Before the Selwyn District Council

in the matter of: Proposed Private Plan Change 73 to the Operative

District Plan: Dunns Crossing Road, Rolleston

Evidence in reply of Donovan Van Kekem (Odour)

Pines RRP Consent Variation - Proximity to Potentially Sensitive Receptors

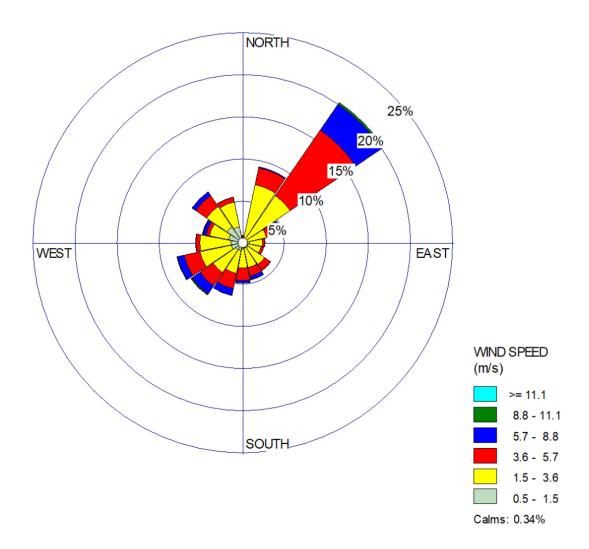
The separation distance from the active composting area to existing dwellings is shown in Figure 4 of the SES Report, reproduced below.

There are four rural dwellings located within 1000m of the area designated for active composting. The approximate minimum separation distances to these rural dwellings are 410m to the northeast of the site, 590m to the southeast, 680m and 850m to the east.

Figure 2: WInd rose for the entire year 1 June 2017 to 31 April 2018, Burnham (source: ADA Figure 5).

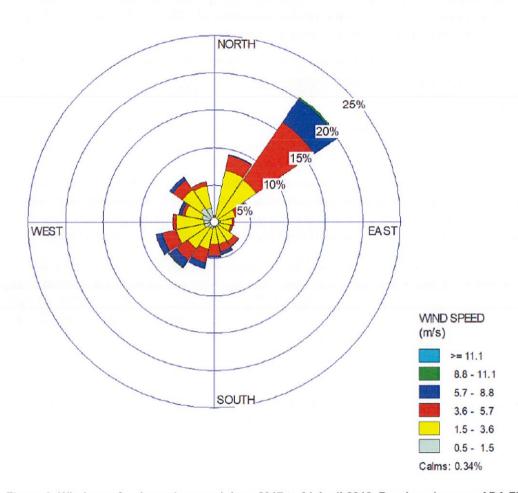
The ADA includes an analysis of wind data recorded during the period 1 June 2017 and 31 May 2018 at the Burnham military camp, 3 km west of the site. The predominant wind is from the northeast, with secondary smaller peaks from the northwest and southwest. The data show that winds from the west (toward the dwellings east of the site) and those from the southwest (toward the dwelling to the north-northeast) each blow approximately 17-18 % of the time (Golder's estimate, based on the wind roses in the ADA). The dominant wind direction is from the northeast – winds from that quarter blow for approximately 30 % of the time but there are no nearby dwellings downwind of the site in that direction. A wind rose showing the distribution of winds across the entire year is shown in Figure 2 below.

Golder agrees with the analysis detailed in the ADA and notes that wind exposure on its own does not indicate a potential effect, but it must be considered along with other factors such as site management and separation distances.
